Project: Jarrahdale road SLK 3.375 to SLK 3.75

Reference: 2005012-01

Safety Audit Document Control Sheet

Project Location:	Jarrahdale road SLK 3.375 to SLK 3.75
Project Proposal:	RSI in support of Blackspot submission
Audit Stage:	Existing road Safety Inspection
Prepared for:	Shire of Serpentine Jarrahdale
Prepared by 1:	Tony Shaw
Prepared by 2:	Shawmac
Audit Team Leader:	Tony Shaw
Audit Team Leader Organisation:	Shawmac
Audit Reference:	2005012-01
Report Issue Date:	12/05/20

Figure 2: Location of Findings

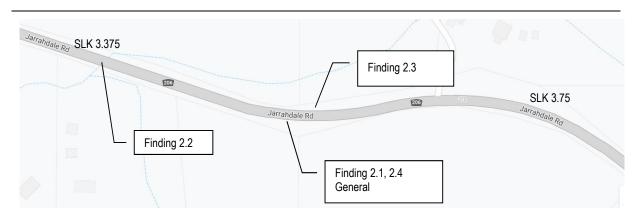
Steep unprotected batter slopes are located adjacent to the carriageway.

Non-compliant barrier is currently installed adjacent to the bridge at about SLK 3.375.

Unprotected culvert headwalls are located adjacent to the carriageway.

shoulders are unsealed and in places exhibit signs of drop off and edge break.

Figure 3: Finding 2.1 - Steep Batter Slopes

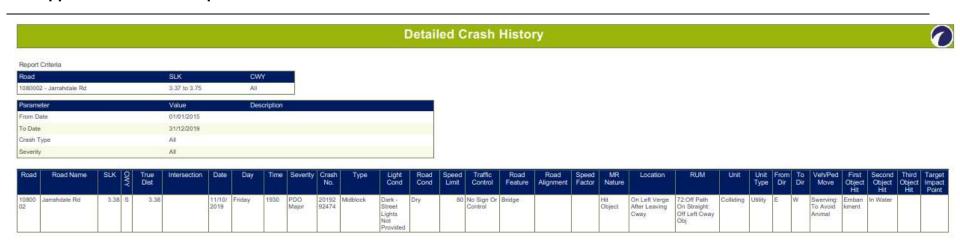
2.1 Finding - Unprotected Batter

Should a vehicle inadvertently leave the roadway in the section of road where there are steep unprotected batters a driver is likely to experience loss of control with the resultant crash causing serious or fatal injury.

- Embankment (fill) slopes batter slopes between 4:1 and 3:1 is traversable but too steep for a driver to recover, and a slope of steeper than 3:1 is critical as the errant vehicle is likely to overturn.

- Embankment height the likelihood of vehicle rollover with a high severity outcome increases significantly where the embankment height exceeds 1.5 m and embankment slopes are critical.

Provide safety barrier along the section of road where the batter slopes exceed 4 in 1 and embankment height is greater than 1.5 metres.
